Value Engineering Study

FINAL REPORT

Widening of Parkway Extension
KY 9009, Campton to Salyersville
Wolfe-Morgan-Magoffin Counties
Study Date: August 17-21, 1998

Kentucky Transportation Cabinet (KTC)
Frankfort, Kentucky

VALUE ENGINEERING RECOMMENDATION # I-11

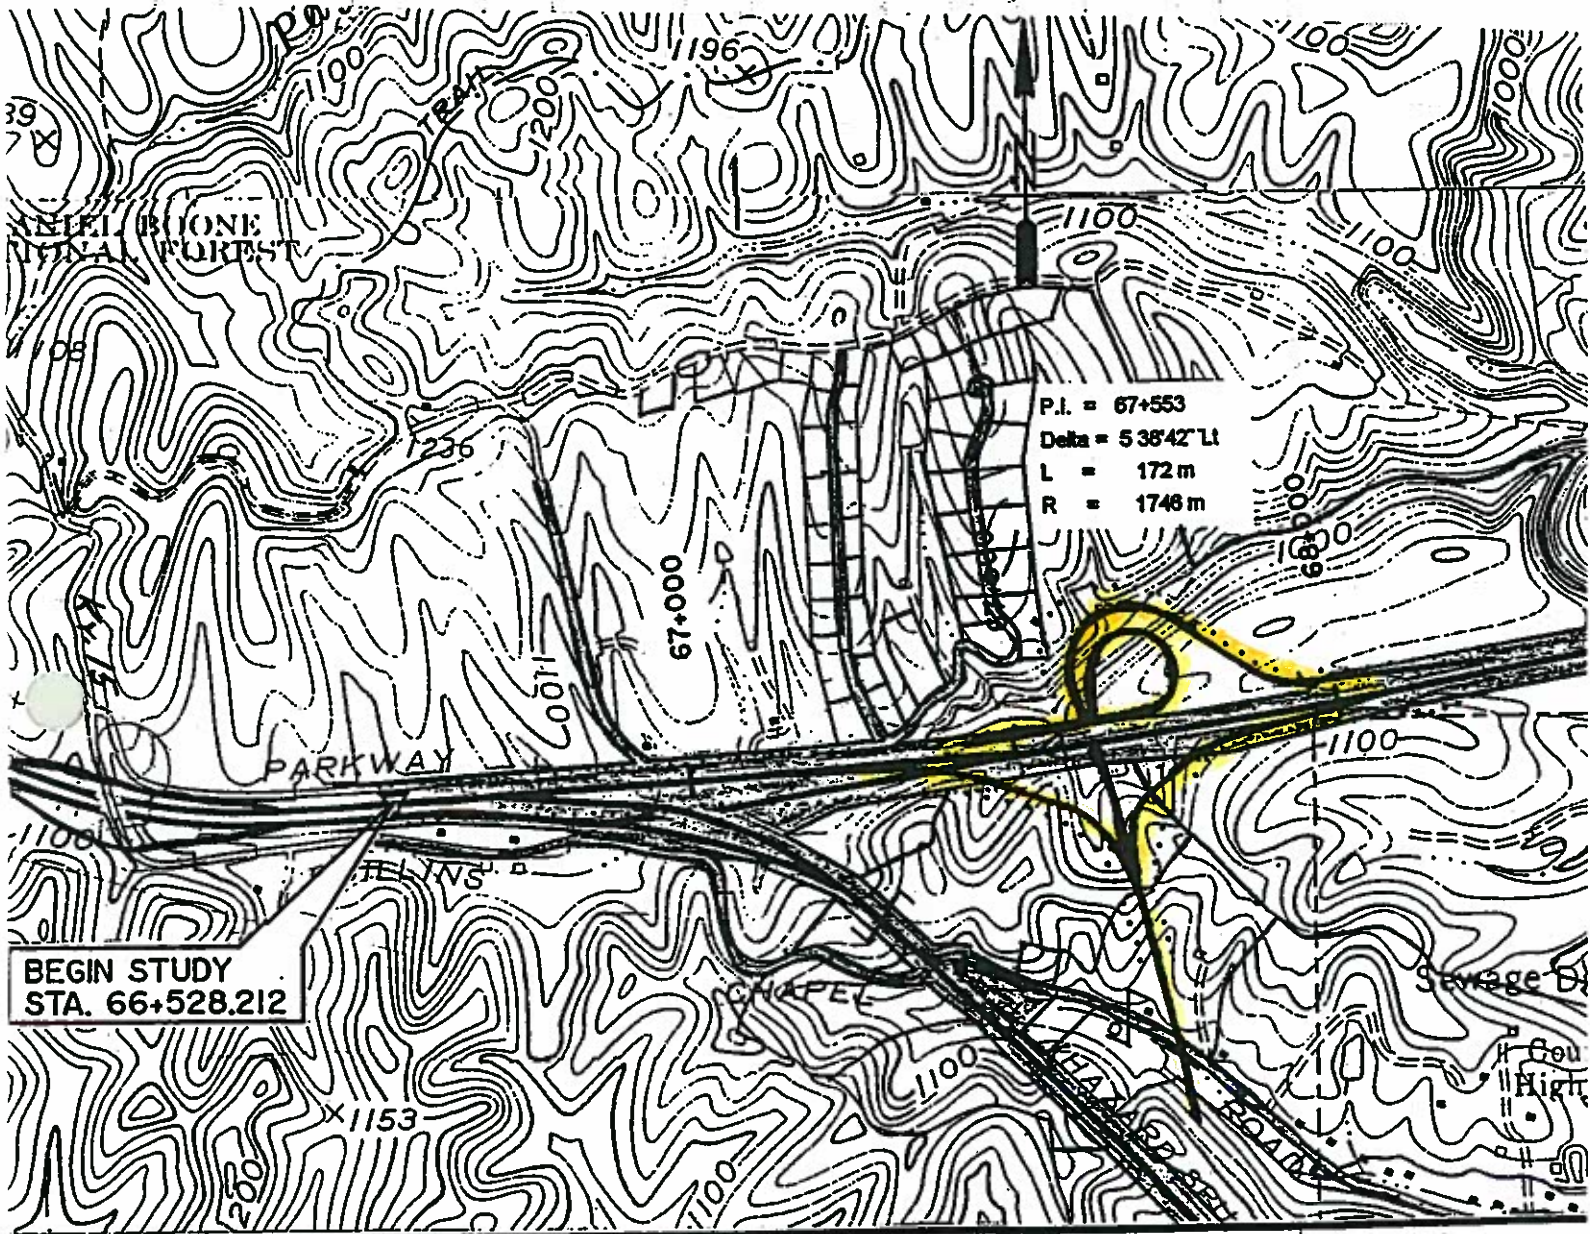
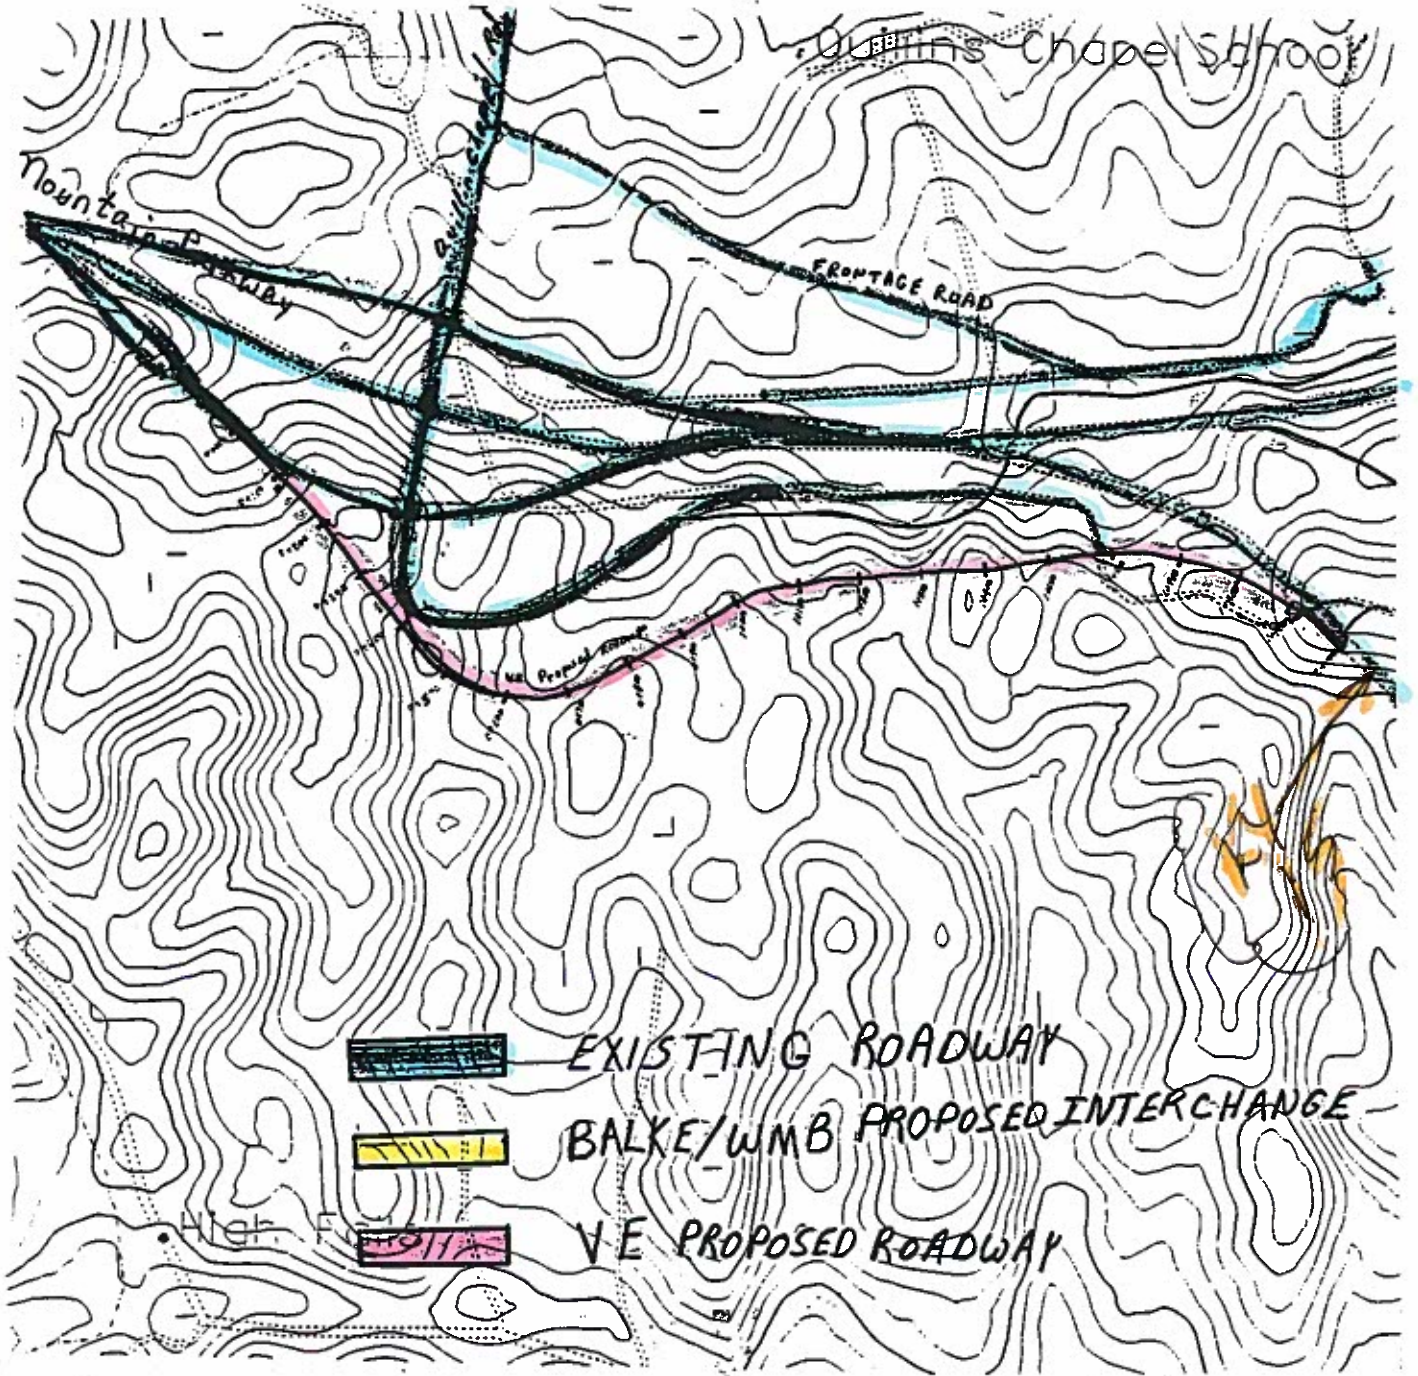
RECOMMENDED CHANGE: Eliminate the proposed interchange for KY15, and modify the existing interchange at KY15 to handle the traffic load.
